REGIONAL REVIEW FINDING

ARC REVIEW CODE: R15060201

Name of Proposal: Decatur Crossing Phase 1 and 2

SUBJECT: **Transportation Division Review**
Project: Decatur Crossing Phase 1 and 2
County: DeKalb
Location: At the intersection of Scott Boulevard and North Decatur Road

SHEET NO. SP-49

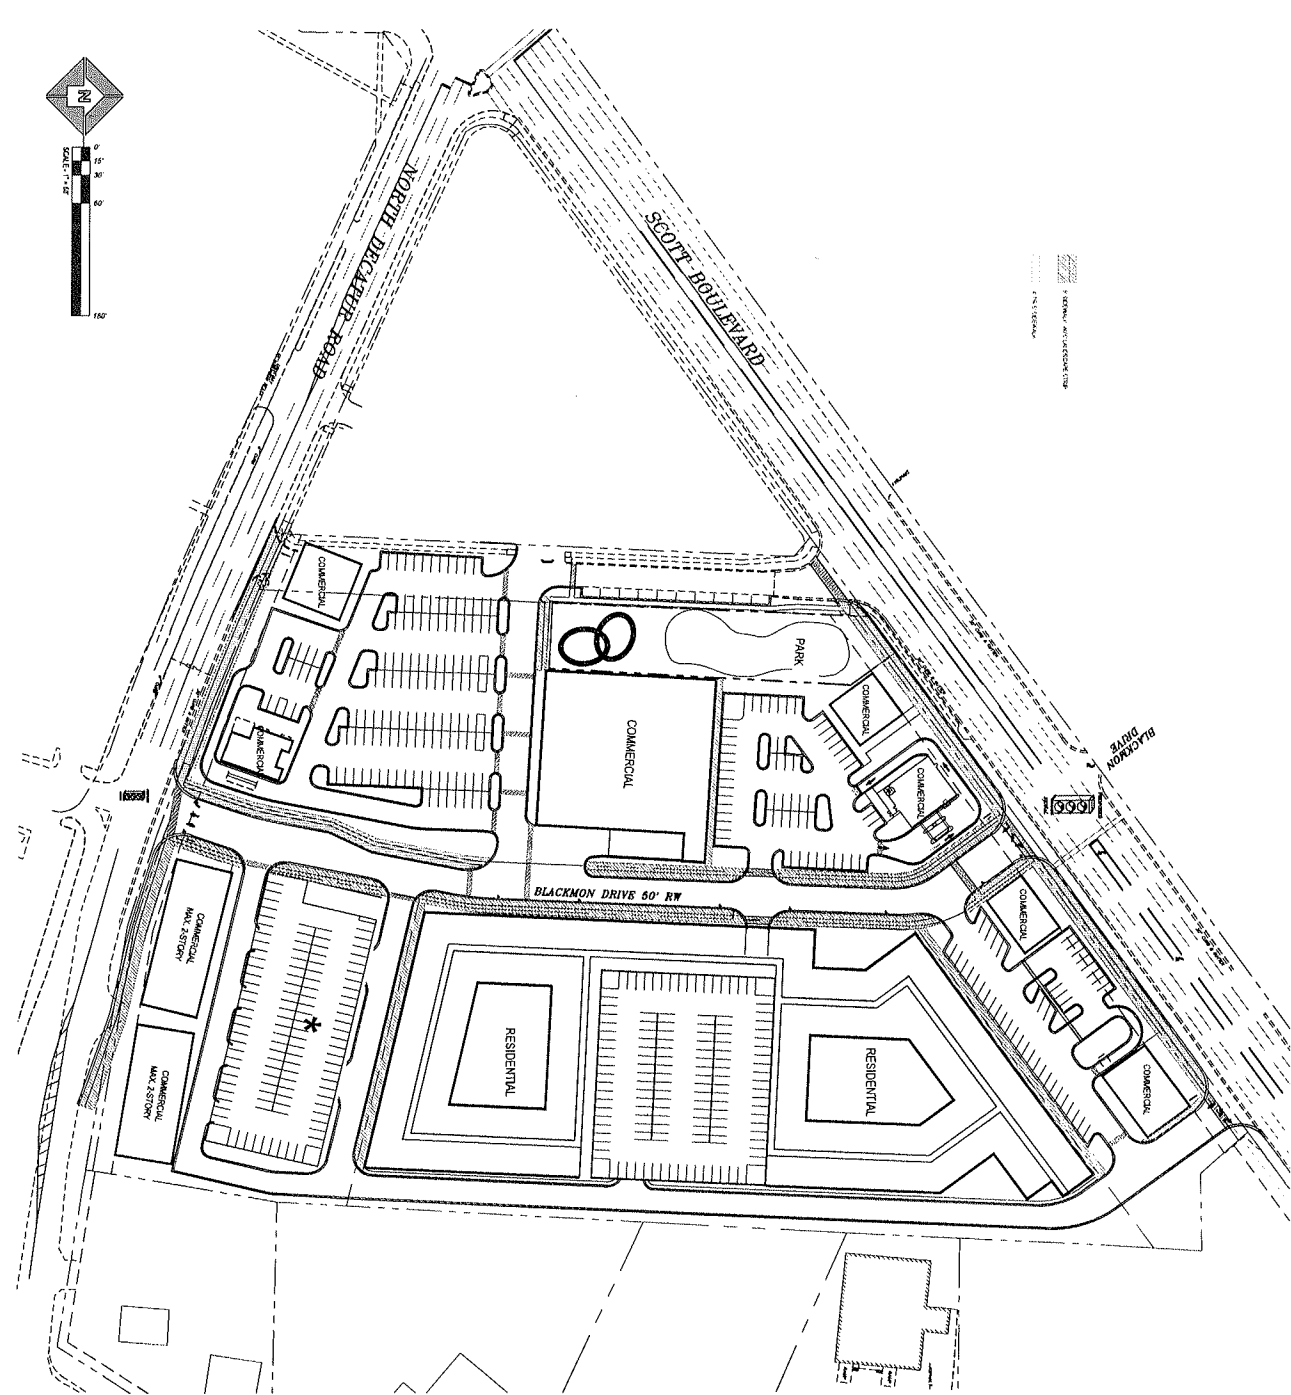
A traffic study was not conducted, so no transportation improvements were recommended for the roadway network. However, the site plan shows new traffic signals at the following intersections:

- Scott Boulevard/US 29/US 78/SR 8 at Blackmon Drive
- North Decatur Road at Blackmon Drive

The site plan shows new traffic signals at the following intersections:

- Scott Boulevard/US 29/US 78/SR 8 at Blackmon Drive
- North Decatur Road at Blackmon Drive

The applicant shall ensure that these proposed signals meet all applicable DeKalb County and/or GDOT requirements for signal spacing, signal warrants, and operations.
